Board of Adjustment Hearing Application - Entry #311

Re: Building Permit Application - 2044 Kingspointe Dr.

SITE PLAN
PROPOSED RETAINING WALLS AND SWIMMING POOL
2044 KINGSPONTE DR, CHESTERFIELD, MO 63005

1 SITE PLAN
C1.0 SCALE: 1" = 20'-0"

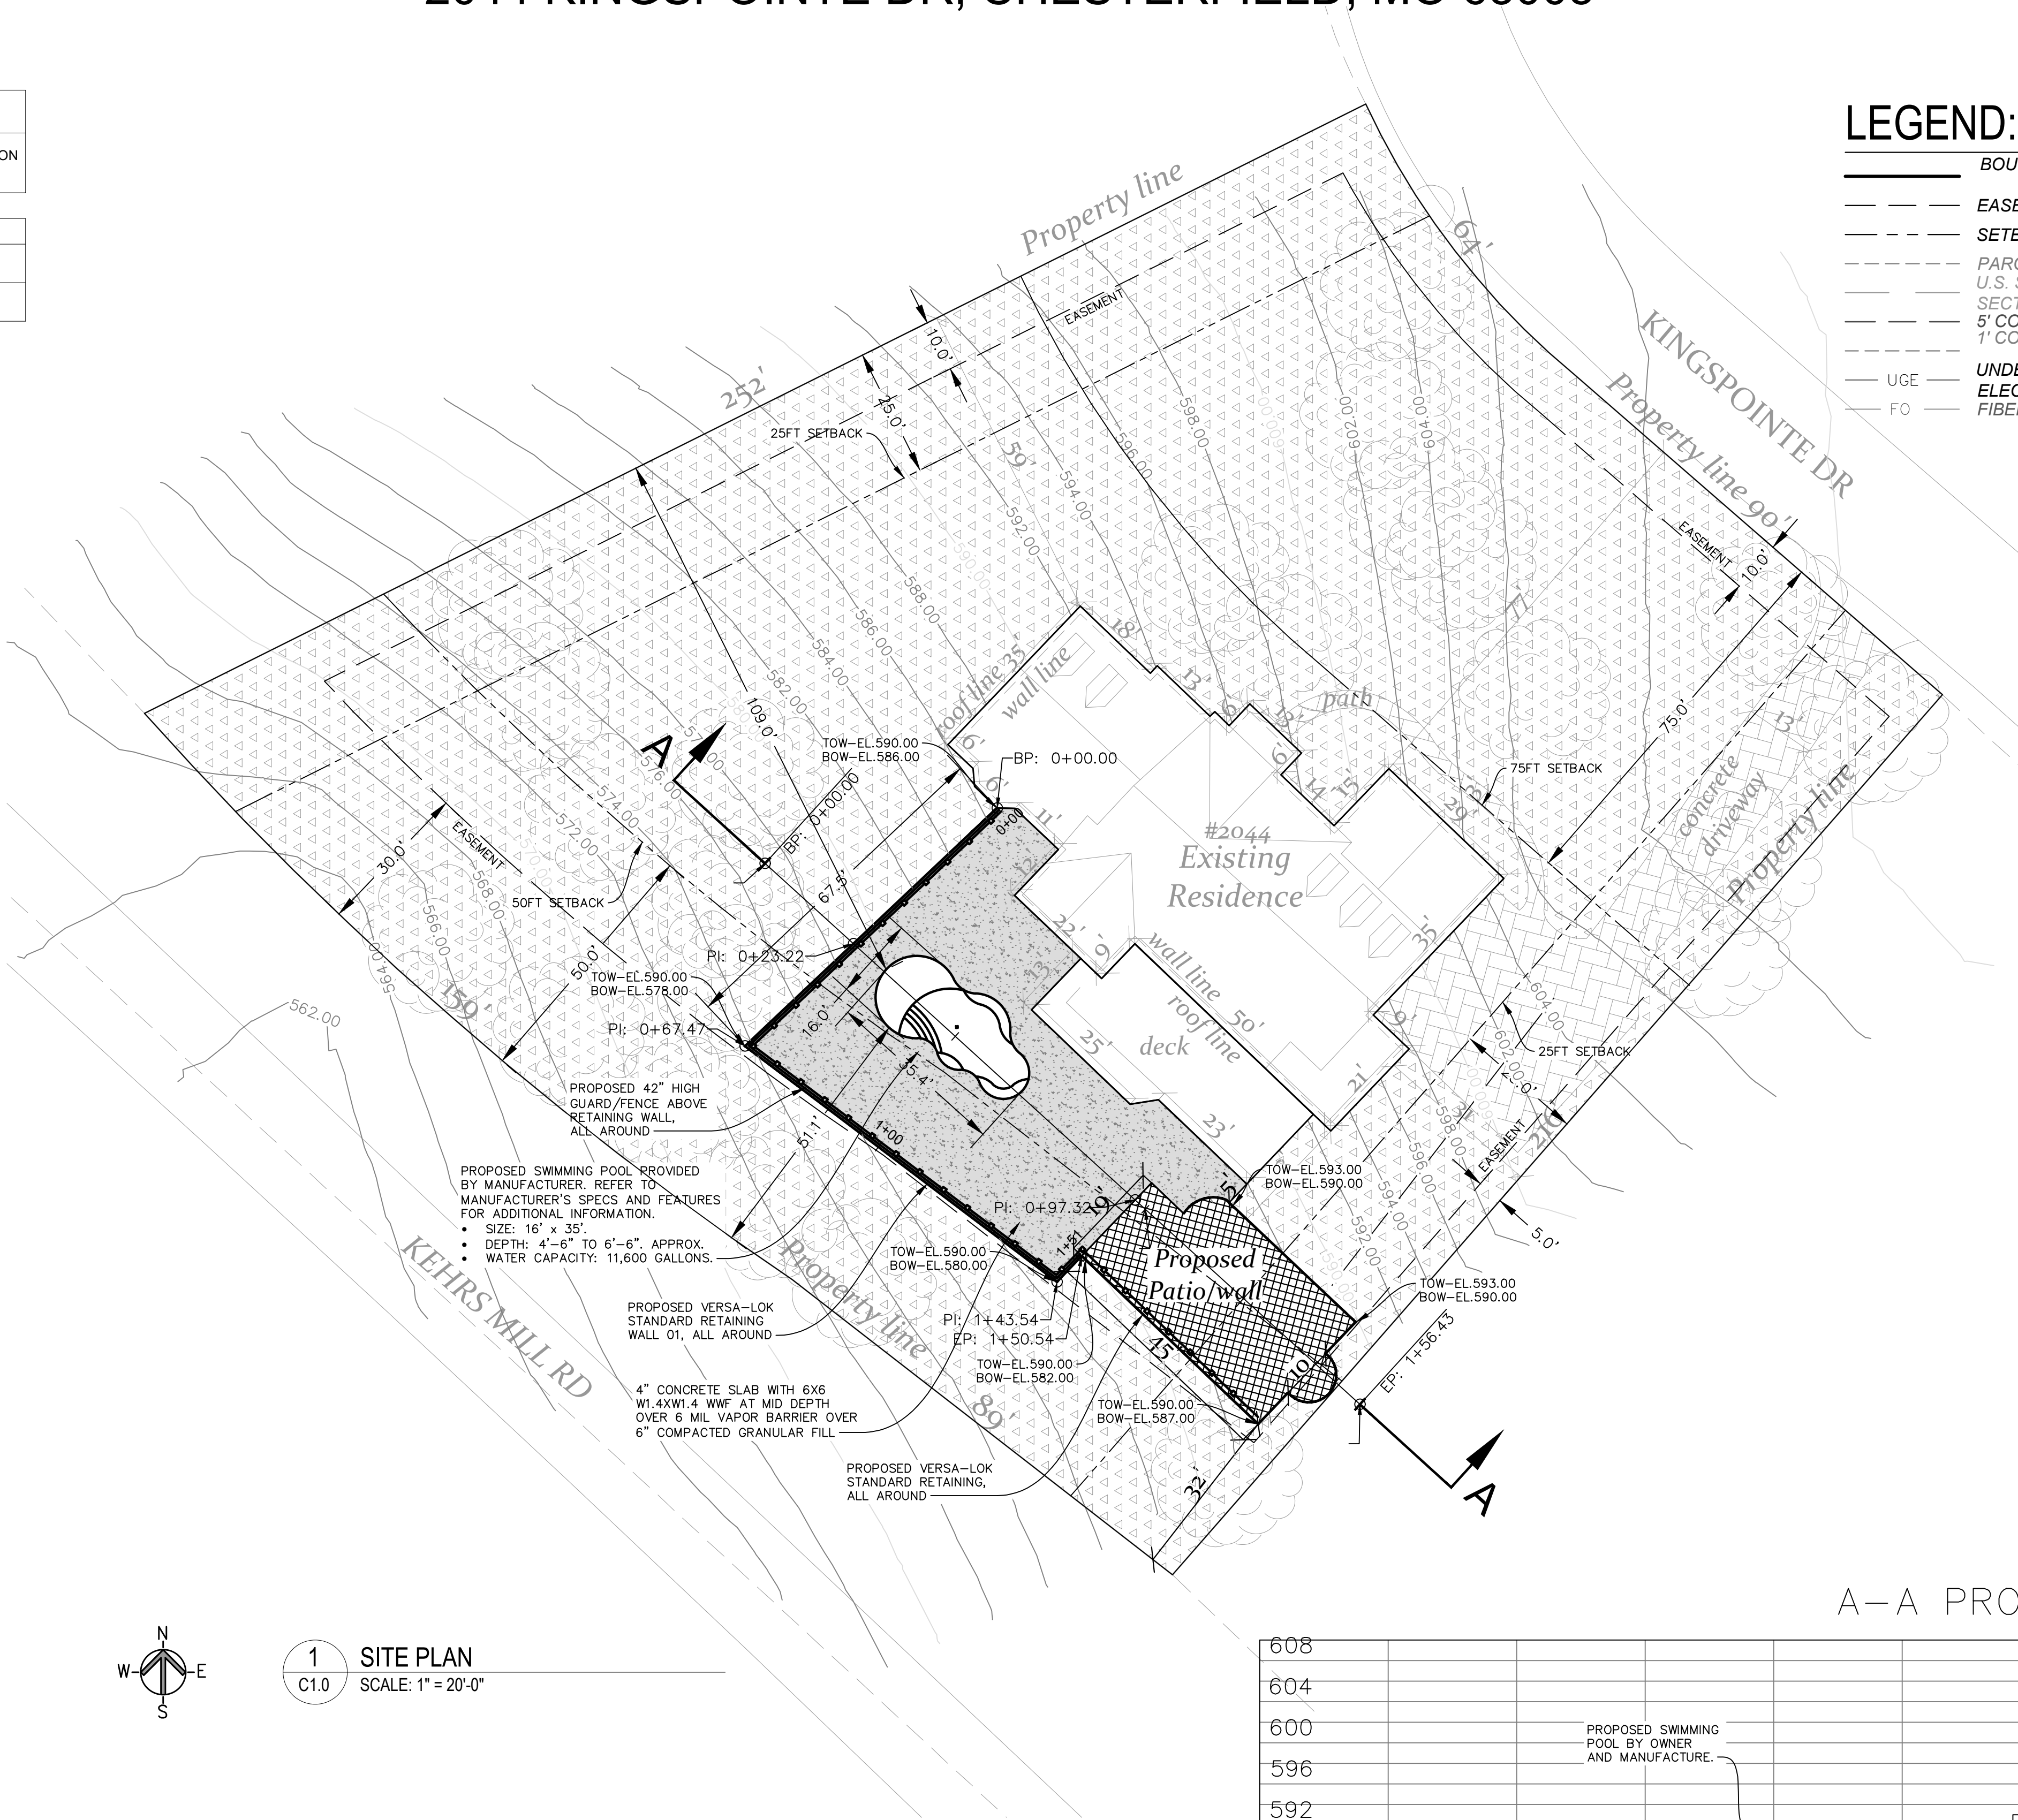
I have reviewed the information submitted for the proposed pool and retaining wall project. Based on that review, the project does not meet Clarkson Valley zoning requirements for the rear 50-foot and 25-foot side (East) building line setbacks. Therefore, I cannot continue my review and must formally deny the application unless and until a variance is granted by the Clarkson Valley Board of Adjustment (CVBOA). The documents you submitted appear to include the details needed for a CVBOA hearing if you choose to proceed. Please contact City staff for information about the CVBOA application process; they have been copied on this email.

1. Long and Transverse cross-sections through the pool. In the sections, show and note the slope of sidewalls and floor, and note the water depth(s) throughout.
2. Assembly/construction section and plan details and pool structural supports and structural reinforcing and location of; pool drains; skimmers or gutters; pool filters; underwater luminaires in pool/spa structure; entry/exit ladders; entry/exit stairs/steps; features including underwater benches, seats, swimouts; diving boards.
3. Water supply system diagram(s); water circulation/filtration system diagram(s); drainage and water disposal system diagram(s).
4. Grades and slopes around pool.
